Airworthiness Directives; Diamond Aircraft Industries GmbH Airplanes

SUMMARY: We are adopting a new airworthiness directive (AD) for certain Diamond Aircraft Industries GmbH Model DA 42 airplanes. This AD requires installing engine exhaust pipe clamps with spring washers, repetitively inspecting the engine exhaust pipe clamps for cracks, and replacing the clamps if found cracked. This AD was prompted by cracks in the affected engine exhaust pipes, which could cause failure of the propeller regulating valve because of hot exhaust gases coming from the fractured pipes. We are issuing this AD to correct the unsafe condition on these products.

2017-15-09 Diamond Aircraft Industries GmbH: Amendment 39-18969; Docket No. FAA-2017-0640; Directorate Identifier 2017-CE-020-AD.

Figure 1 to paragraph (f)(1)(ii) of this AD:
Sequence of Actions for Exhaust Clamp Installation of
DAI Work Instruction WI-MSB 42-120, Revision 3, dated July 6, 2017

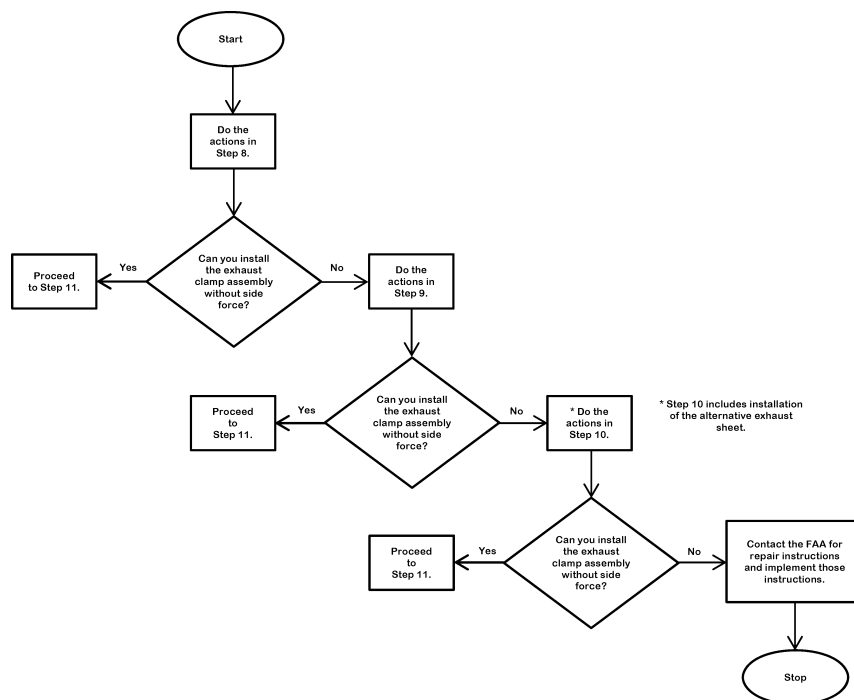
(ii) Reinstall any uncracked clamp or replace with a new clamp and incorporate spring washers following III.2 Action 2—installation of additional exhaust clamp in the INSTRUCTIONS section of DAI Work Instruction WI-MSB 42-120, Revision 3, dated July 6, 2017, as specified in DAI Mandatory Service Bulletin MSB 42-120/2, dated June 7, 2017. See figure 1 to paragraph

(f)(1)(ii) of this AD for additional information on the sequence of installation actions as identified in DAI Work Instruction WI-MSB 42-120, Revision 3, dated July 6, 2017. Credit is not given for installation of an engine exhaust clamp installed following DAI Work Instruction WI-MSB 42-120, Revision 1, dated December 14, 2016, (installation of exhaust clamp without spring washers), or DAI Work Instruction MSB-42-120, Revision 2, dated June 7, 2017.
